Landrover V8 Electronic Ignition

Replacement Modification Engineering Change Instruction

Figure 10 – Wiring and Layout Template.

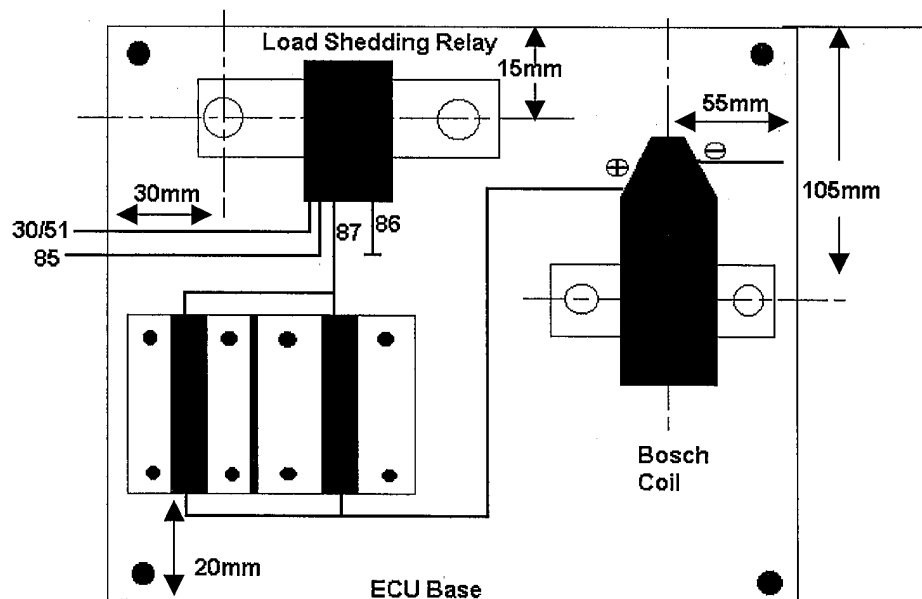
- (1) Rotate engine to TDC No 1.
- (2) Remove electronic control box (ECU) from L/H fender.
- (3) Remove all components from ECU base plate leaving rubber feet.
- (4) Mount 1x load shedding relay on upper left of base plate.
- (5) Mount 2x 6.8 ohm resistors on lower left with connectors facing down.
- (6) Mount Ignition coil on base plate with mounting bracket on centre line of base plate
- (7) Wire components as per Fig. 1 Wiring and Layout Template.
 - (a) Use black wire from one battery only (12 Volt) to relay terminal 30/51.
 - (b) White Ignition feed wire is connected to relay terminal 85.
 - (c) Relay terminal 86 is ground.
 - (d) Relay terminal 87 is connected to resistors.
 - (e) Resistors are connected to Coil positive terminal and negative to common connection of points and capacitor in distributor.

- (8) Re-mount base plate on L/H fender.
